PLANNING COMMISSION REPORT

Ashler Hills Park MUMSP 18-UP-2021

1. A recommendation to City Council regarding a request by owner for approval of a Municipal Use Master Site Plan for a new park on a +/- 15-acre site with Multiple-Family Residential Environmentally Sensitive Lands (R-5 ESL) zoning located at the northwest corner of E. Ashler Hills Drive and N. 74th Way (APN: 216-51-098).

Figure 3.
 1/24/18 Plan (shaded purple) superimposed over current proposed site plan, showing expansion from 2.8 to 6.8 acres.
 In the current proposed site plan, all the proposed "improvements," except the parking lot, lie beyond the site perimeter of the 1/24/18 Plan.

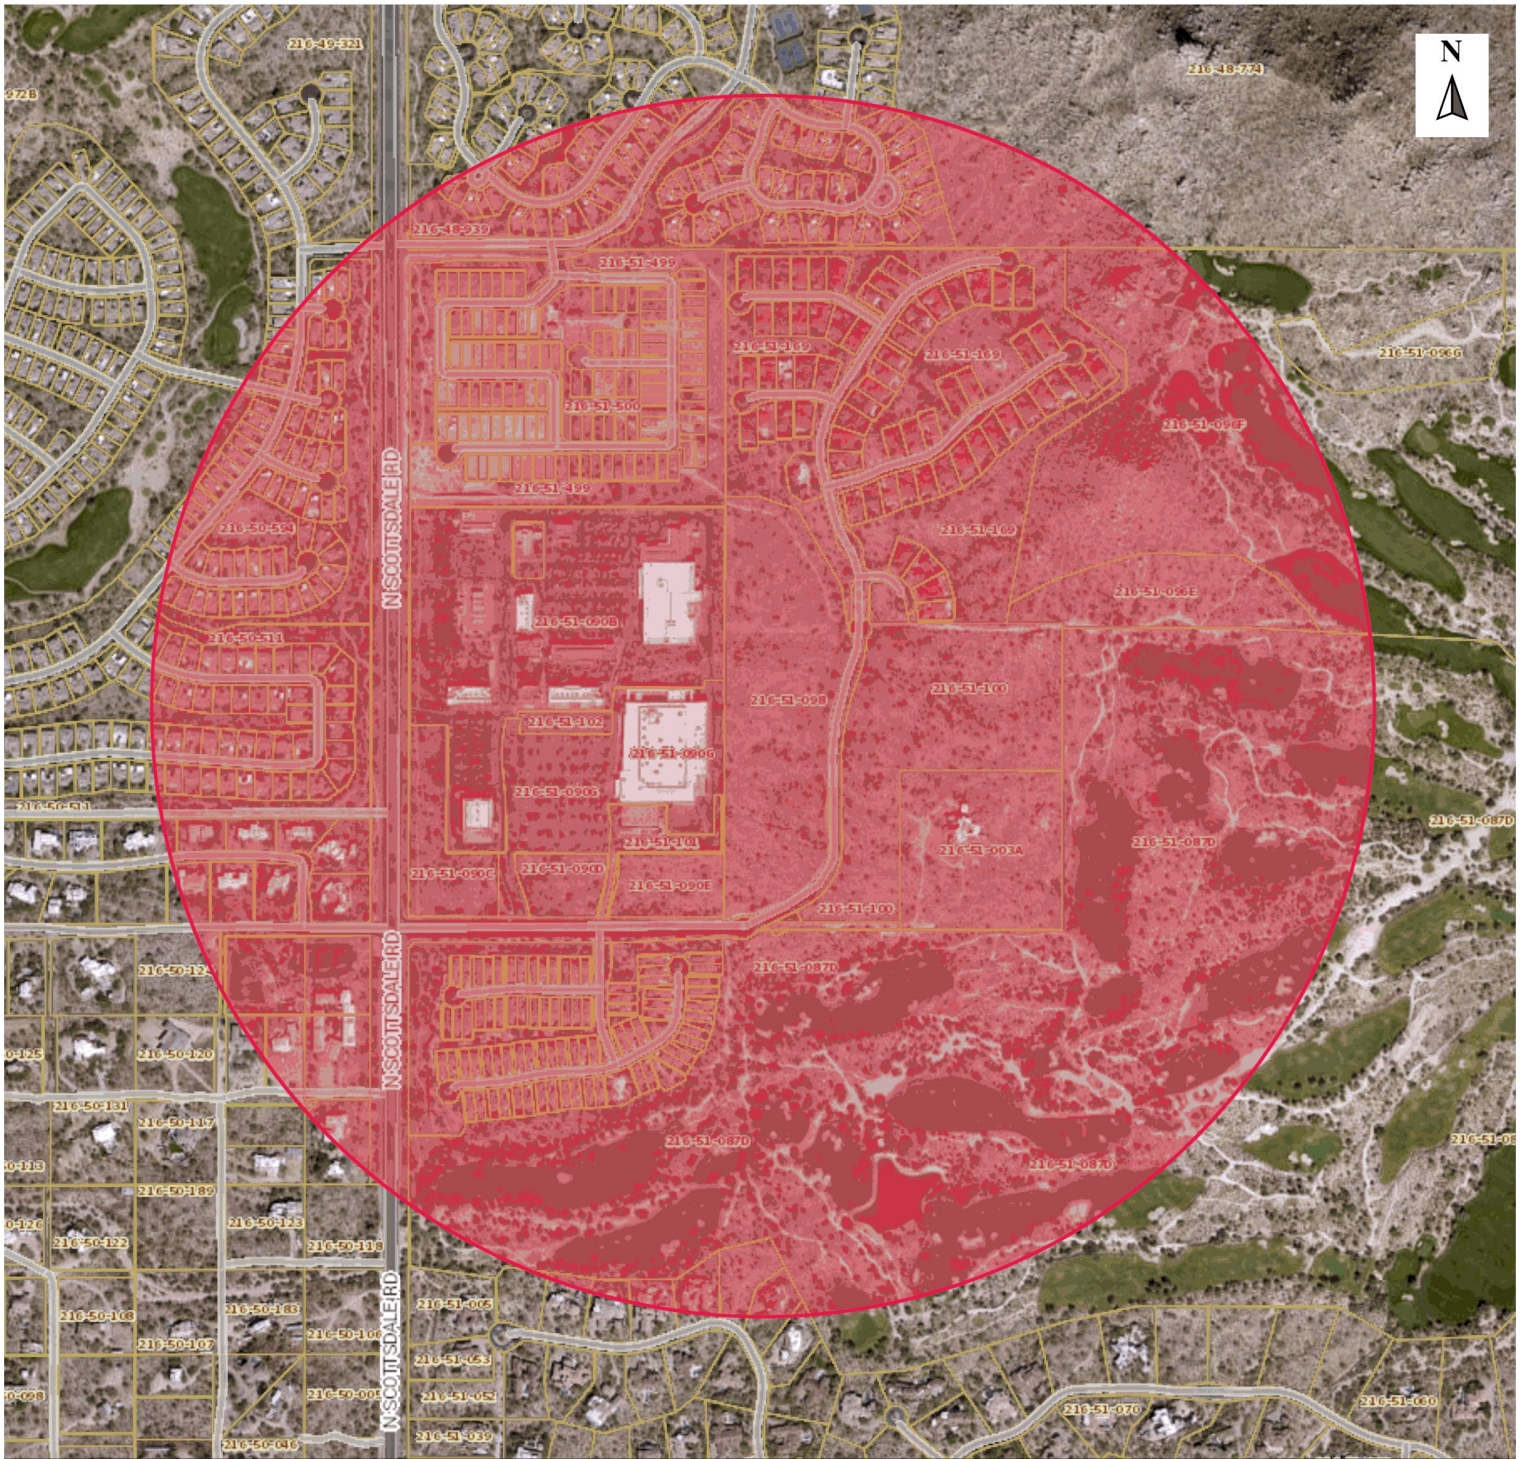
The current proposed site plan was prepared under that contract. Yet, the area to be "developed" has ballooned – not from 2.8 to "3 or 4" acres – but **from 2.8 to 6.8 acres**. It has more than doubled in size. In fact, all the proposed "improvements," except the parking lot, lie beyond the site perimeter of the 1/24/18 Plan (Figure 3 attached).

The parking area has grown in concert with the number of sport courts. The parking lot in the 1/24/18 Plan has 19 parking spaces. The parking lot in the current proposed site plan has almost quadrupled to 70 spaces.

Figure 6. Blind curve safety hazard at City's proposed access (park entrance)

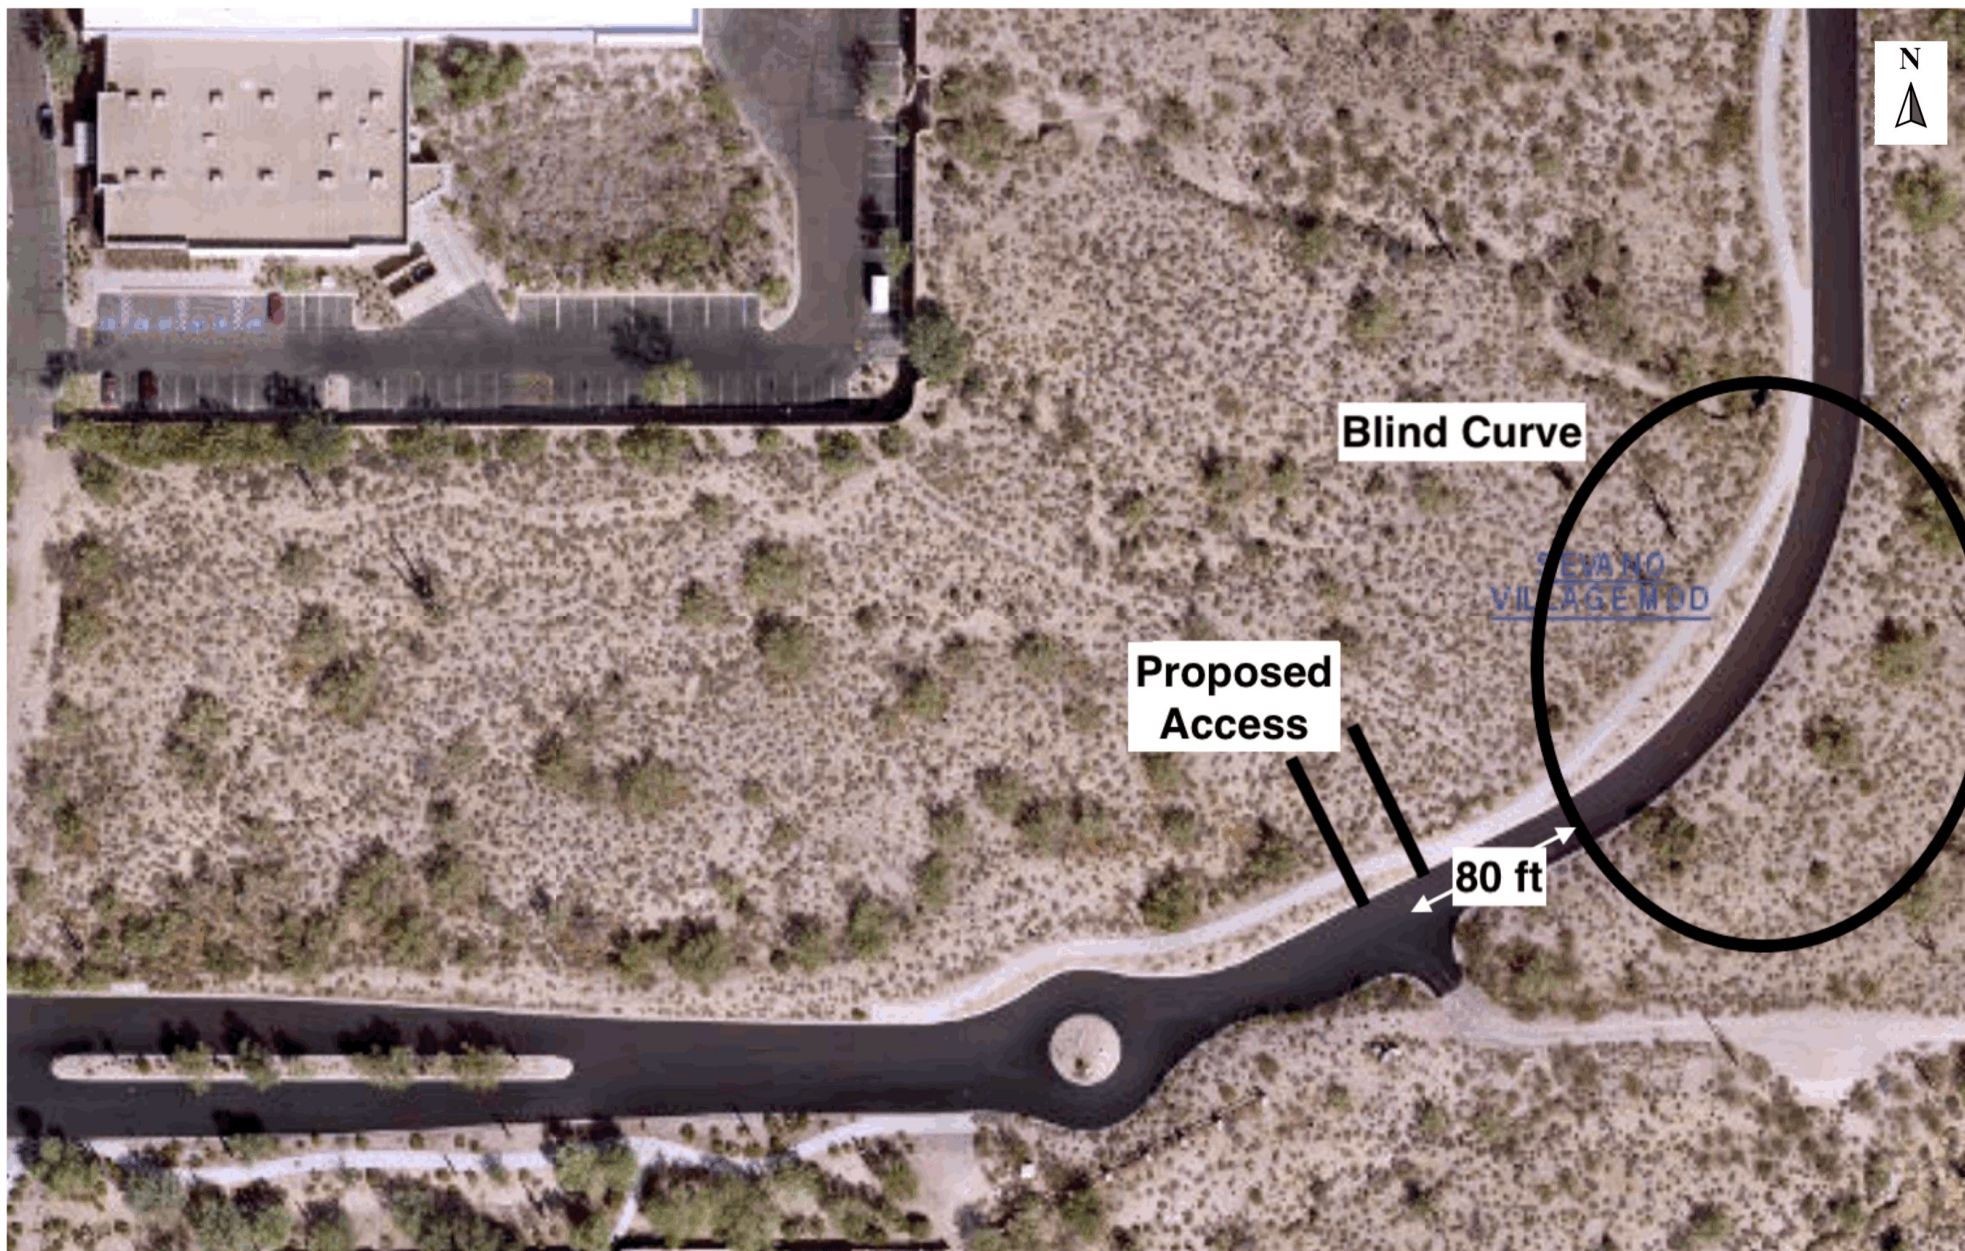
At the park site, east-west Ashler Hills Drive turns to become north-south 74th Way. The northeast portion of that long turn has the shortest radius of curvature; this sharp curve is a blind curve (Figure 6 attached).

Drivers travelling S-W out of the blind curve and drivers entering and exiting the park would not see each other until they are within 80 feet of each other – a distance far short of the Minimum Stopping Sight Distance and the Minimum Tangent Approaching Intersection required per DSPM (Appendix 5-3A).
